PROPOSAL 2-1 (2009)

SCOPE: Sec. 12.2.5 of the 2009 Provisions

3 **12.2.5.5 Minimum Flexural Strength of Columns in Special Moment Frames**

Figure A

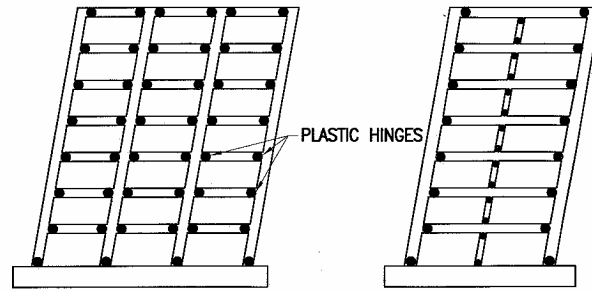
4 The proposal represents a fundamental modification of requirements for strong-column/weak-
5 beam because column and beam moment strengths are to be summed for all columns at each
6 level for each plane of resistance. The sum of column strengths framing *into the underside of a*
7 *level only* are compared to the sum of beam strengths at that level. For example, in the three-bay
8 planar frame of Figure A, the formula compares the sum of four column moment strengths to the
9 sum of six girder moment strengths.

Figure B

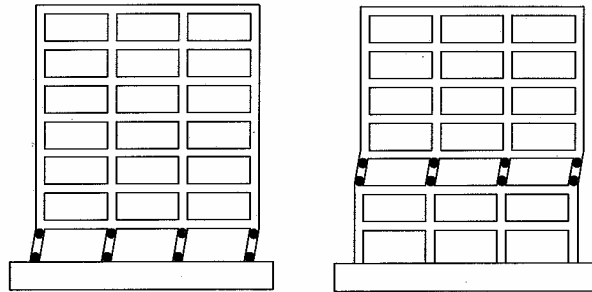
10 The story approach is shown by plastic analysis studies to be an appropriate provision against the
11 formation of undesirable story mechanisms. Desirable and undesirable plastic mechanisms are
12 shown in Figure B.

18 Compared to current requirements, this proposal requires, on average, stronger columns and/or
19 weaker beams. The proposal can provide design flexibility and economy by allowing individual
20 columns to be weaker than adjacent beams, provided that there is enough strength in other
21 columns to prevent a story mechanism. (See upper right of Figure B)
